Product Change Notification

PCN-FDC-8567-2023

Business Unit	Product Line Code	Type of Change	Action	Date of Issue
FDC - Field Device Connectors	ABN	Product Change Notification	Notify Distributors and Field	2/24/2023

Description for Product Change Notification

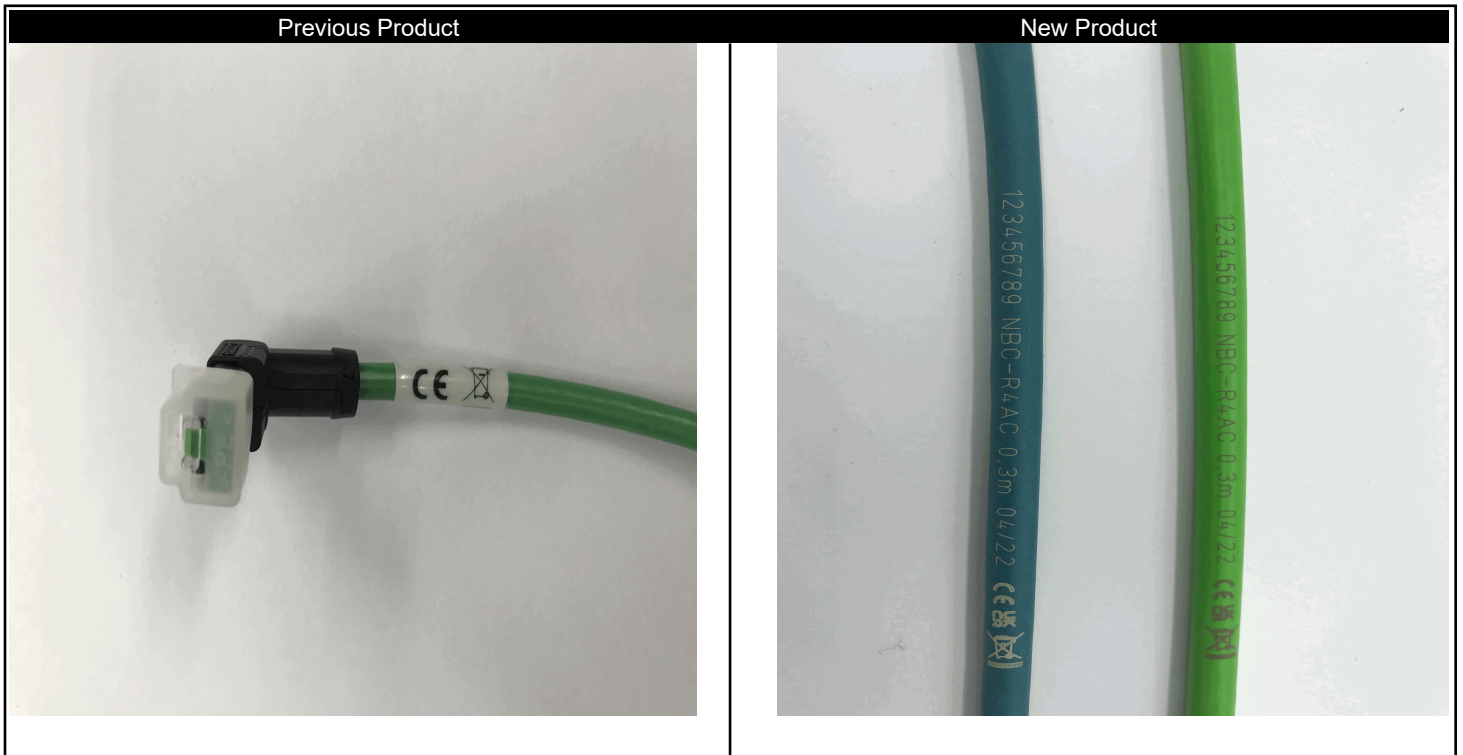
Due to steadily increasing requirements and approvals, a larger number of approval markings have to be applied directly to the products. Currently, the patch cables are equipped with a wrap-around label in which various approval markings (CE, WEEE, UKCA, UL) are shown. In order to improve the legibility of the markings and eliminate the wrap-around label going forward, markings will be lasered directly onto the cable along with other cable markings.
